Official Transcript of Proceedings
NUCLEAR REGULATORY COMMISSION

Title: Advisory Committee on Reactor Safeguards
Reliability and Probabilistic Risk Assessment

Date: Wednesday, September 18, 2019

RELIABILITY & PROBABILISTIC RISK ASSESSMENT

Cognition Model—Overview

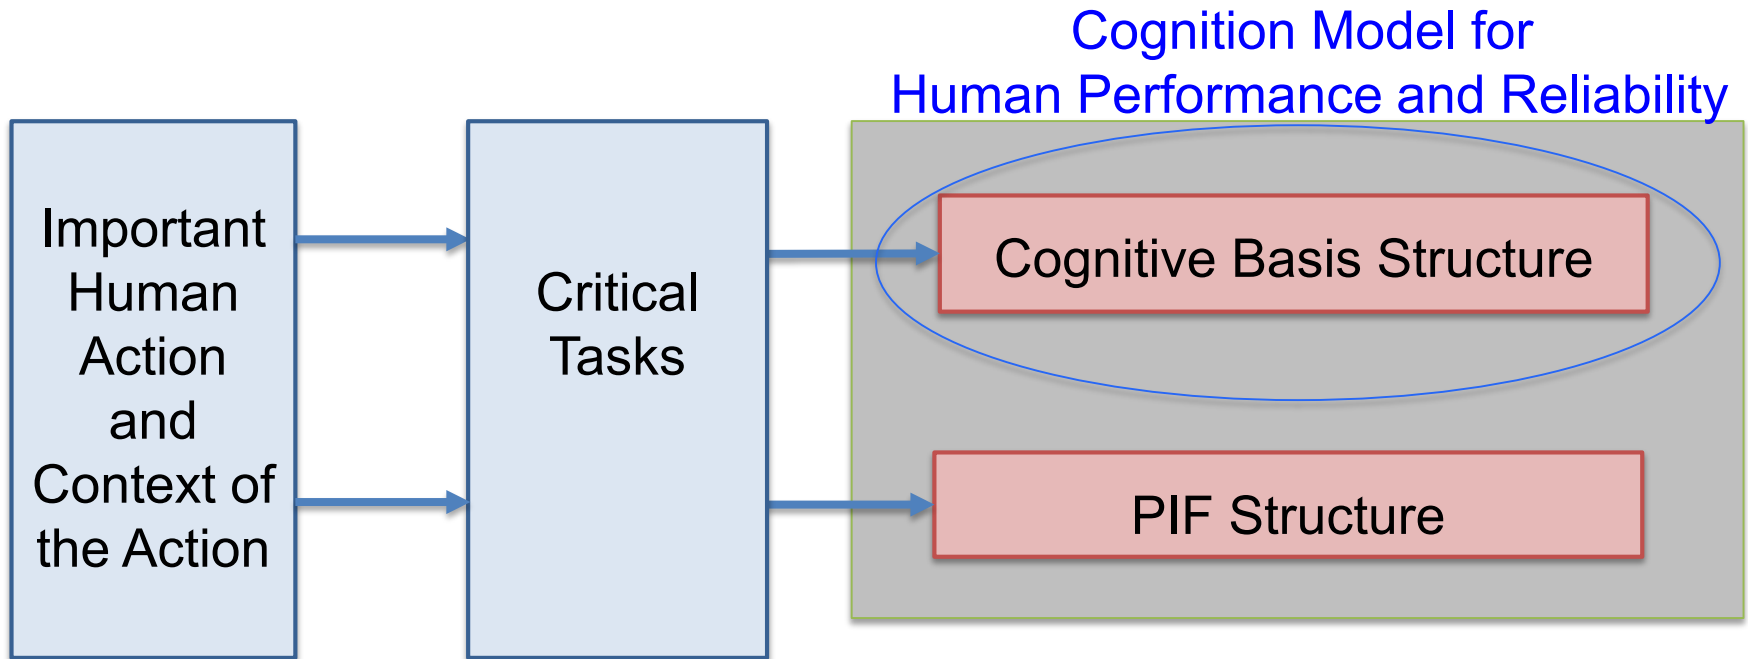
3 Figure 3, when you come to it, with all
4 the cross connections is really not helpful without
5 some more explanation. These new names pop up for the
6 first time. There are lines that you don't know why
7 they're going where they are.

HEP Quantification— P_c (continued)

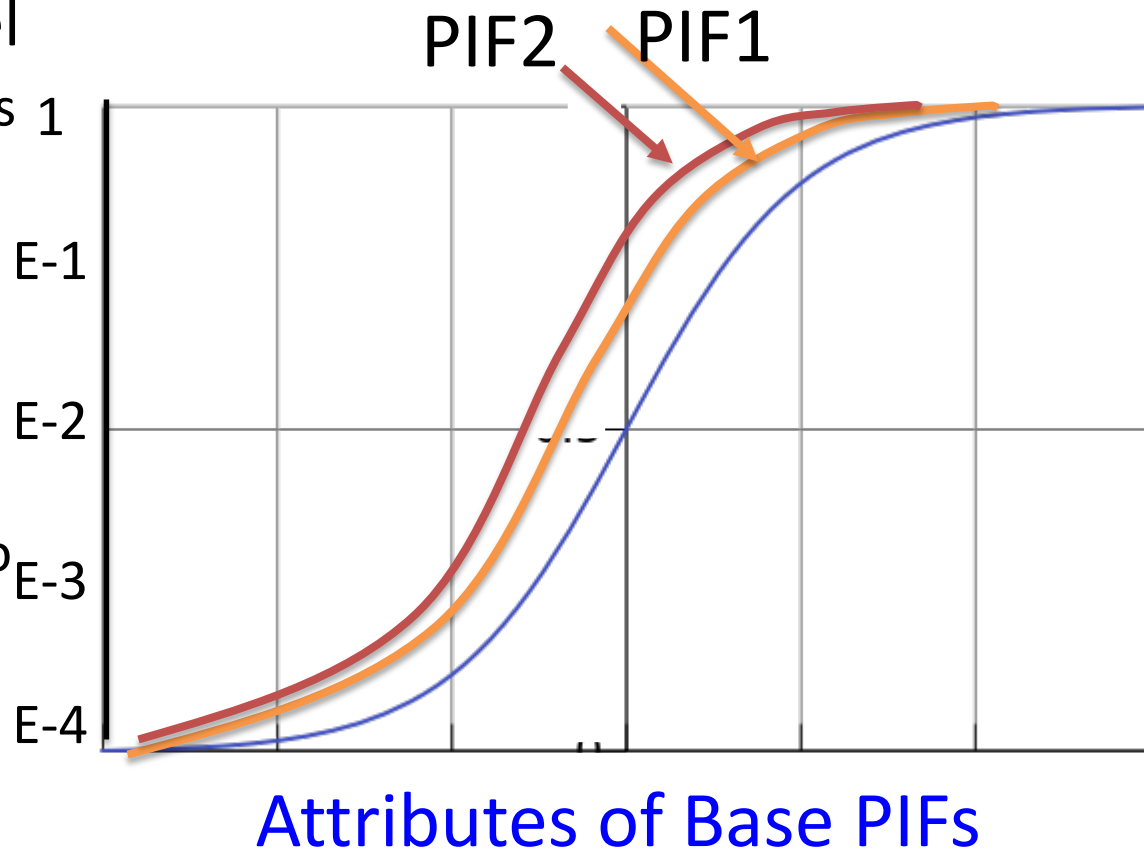
9 CHAIR BLEY: It looks like it's trying to
10 show me something quantitative, how I could use this
11 to pick off a number.

9 CHAIR BLEY: -- the HEP goes up as the
10 PIFs get worse. If that's all you're trying to show
11 me, I didn't need the curve.
